OTWAY WATER

Book 42 J

Comment on Barwon Water's, “Boundary Creek, Big Swamp and surrounding environment Remediation and Environmental Protection Plan”

Otway water Book 42 J, Comment on REPP.

Bore Number 82840 along Wire Lane.

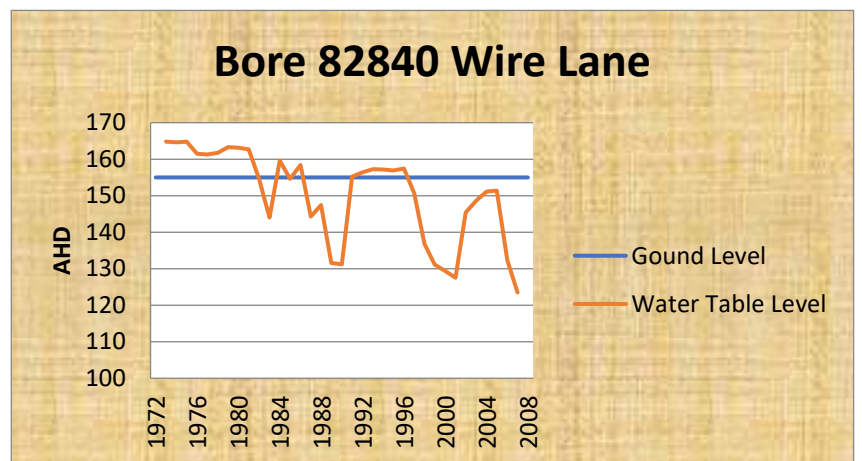
It was predicted that Boundary Creek would stop flowing due to groundwater extraction and as predicted, it actually took place (see page 20 for comment on the wording “as predicted”).

In the early 1970s when Bore 82840 was first drilled into the aquifer this was the height of the water spurting out of the ground, (8.7 metres above ground level). As at November 2007 extraction had lowered the water table at least 40 metres lower and the Millennium Drought was just beginning.

The piezometric level in 1972 was approximately 165 m AHD. By 2007 it had been lowered by approximately 40 m. Ground level at the Wire Lane observation bore is approximately 157 m AHD.

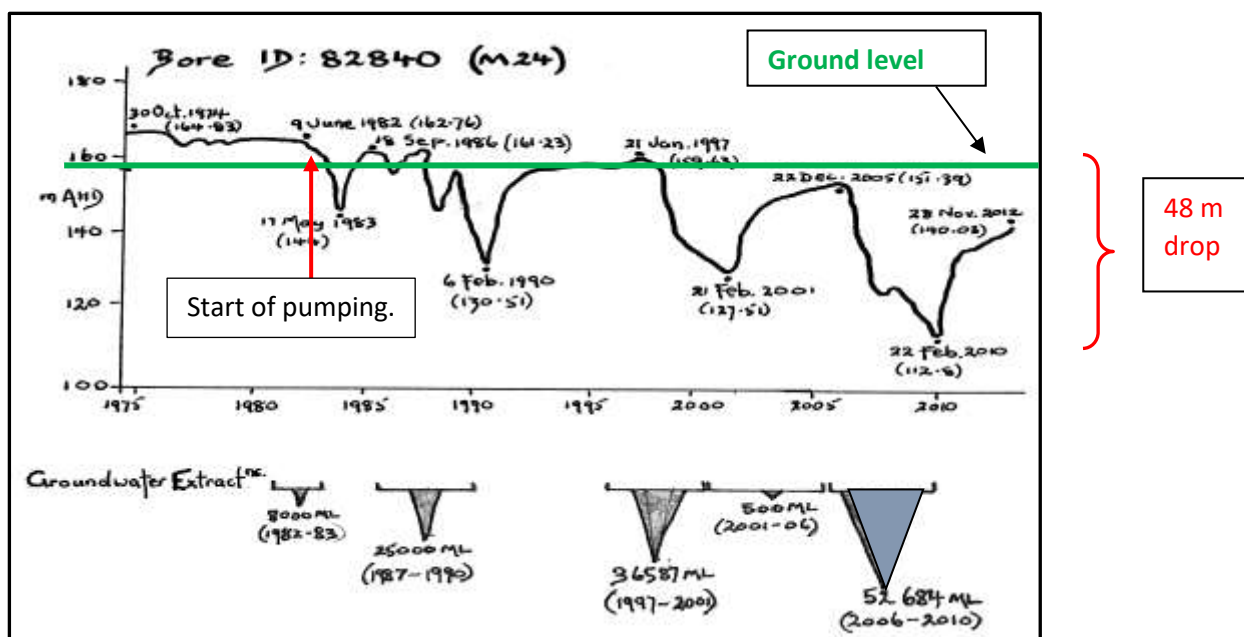
(DEWLZ) is dropping by 10cm a year. The report goes on to say that at the current rate of decline watertables will drop in this region in the order of one metre in ten years. This report took into account climate change and present groundwater extraction in the South West. However, this study did not include the Barwon Downs Borefield area of influence where water table levels have been forcibly dropped tens of metres, in some cases at least 50m.

The above observation bore water table levels show how the Barwon downs Borefield extractions have skewed the DEWLZ way below the natural variability.

This observation bore hydrograph down the Kwarren groundwater flowpath shows a constant decline associated with and impacted by the Barwon downs Borefield extractions. There are no extraction bores in the Kwarren area that can account for this decline. This decline is much more than the 2006 GHD report predicted and is not a natural variability. There has been no response in the hydrographs during those wet winters since the Millennium drought. The Wade report⁽³⁹⁾ clearly accounts for this decline as a direct result of groundwater extraction from the Barwon Downs Borefield.

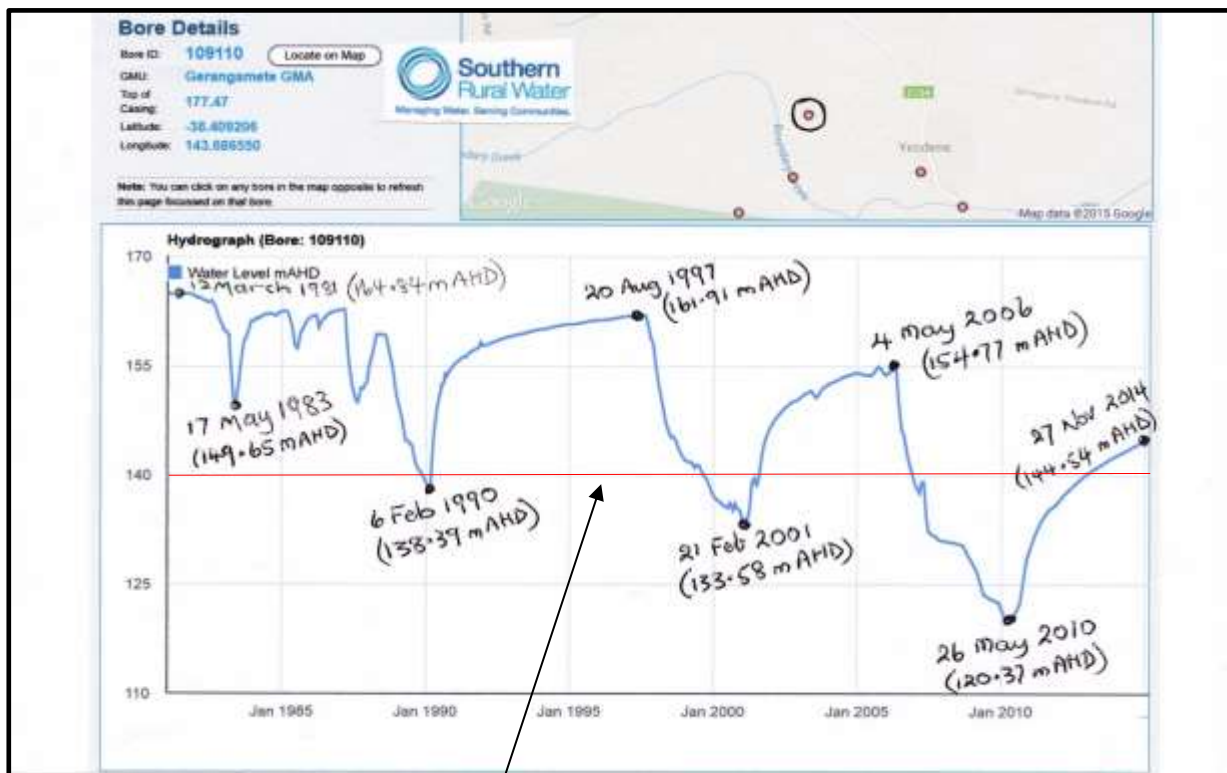
This seasonal fluctuation is the Dynamic Equilibrium Water Level Zone. The Pebble Point formation is one of the Lower Tertiary Aquifers the Barwon Downs Borefield extracts groundwater from, and, as seen in the hydrographs in the Barwon Downs Borefield region, they suffer enormous fluctuation and drawdown impact.

The thickness of this red line represents an approximate 20cm fluctuation.

This observation bore is situated inside the drawdown impacts from the Barwon Downs Borefield and demonstrates the enormity of the impact on natural variation from groundwater extraction. The Lower Tertiary Aquifers have been drawn down that far they no longer are able to buffer the hydrological sensitive and water dependent surface receptors.
